## Land Use Application Updates (per 2/28/23 email)

LAND USE APPLICATION  
3/10/2023

1 ZONE B LAYOUT/JOINING  
1" = 20'-0"

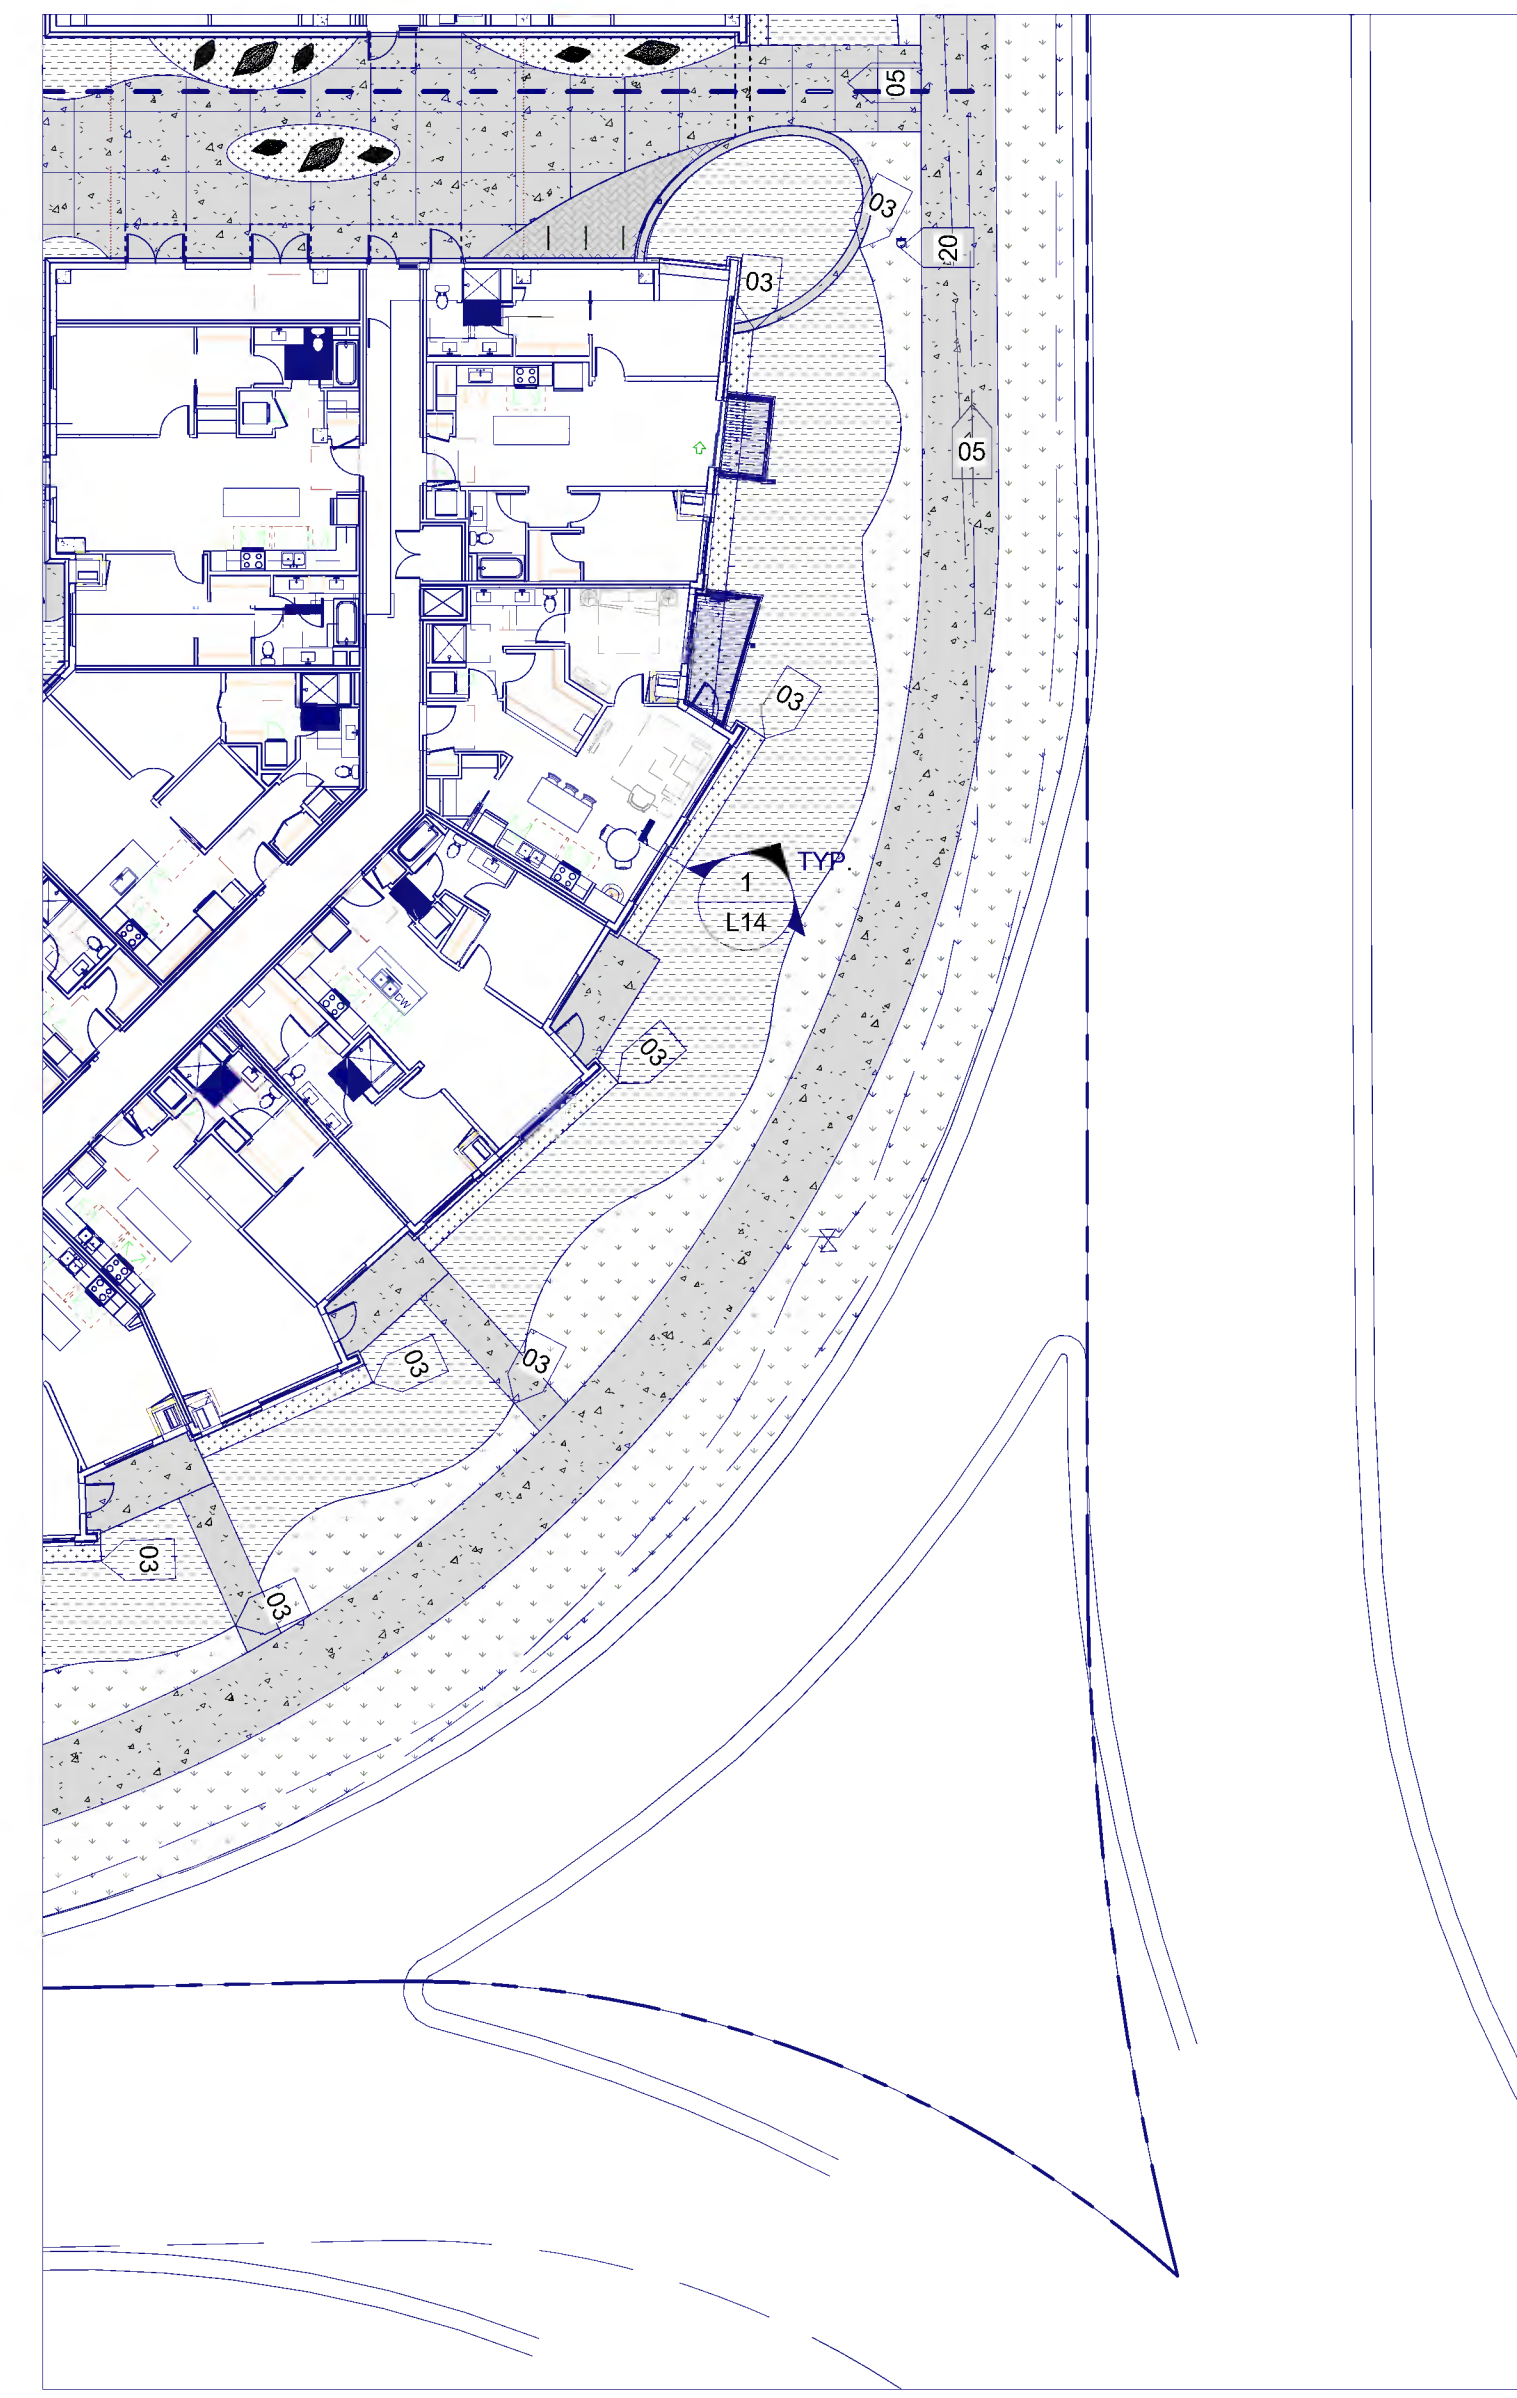
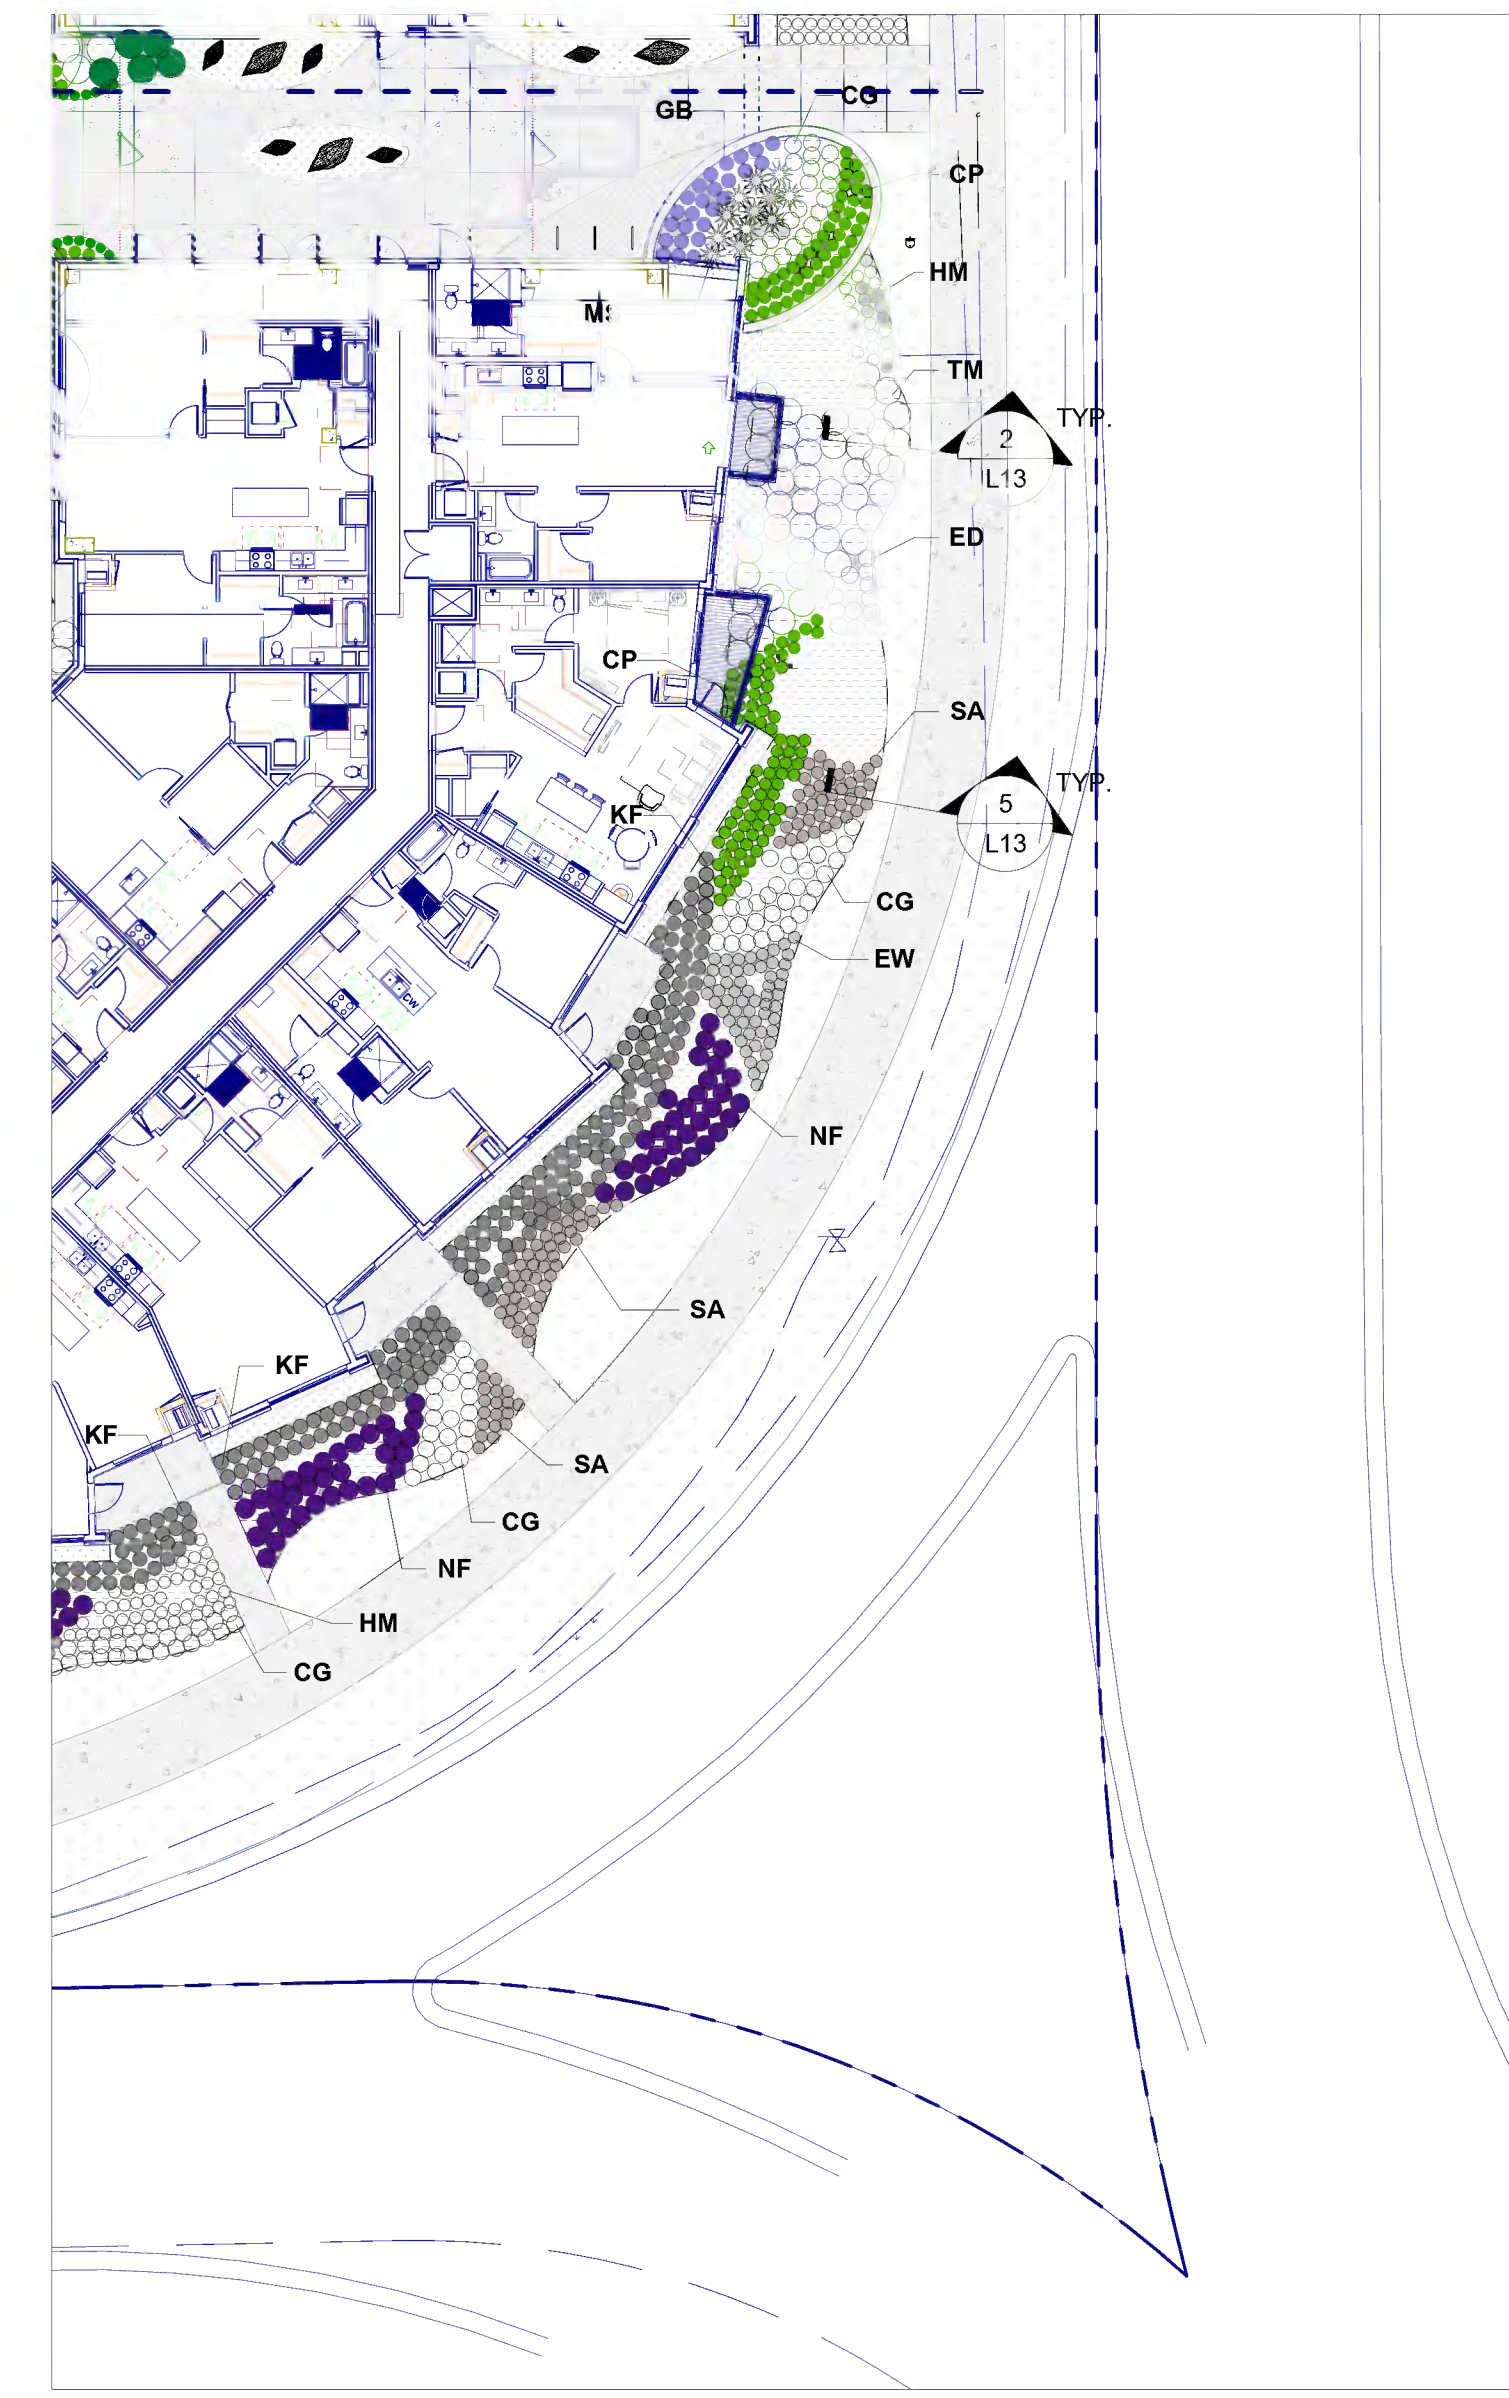
The plan must also incorporate pedestrian furniture, wayfinding signage from the Opus placemaking guide and dog waste bags. See top exhibit of L3 sheet, left exhibit of L4 sheet, and left exhibit of L5 sheet.
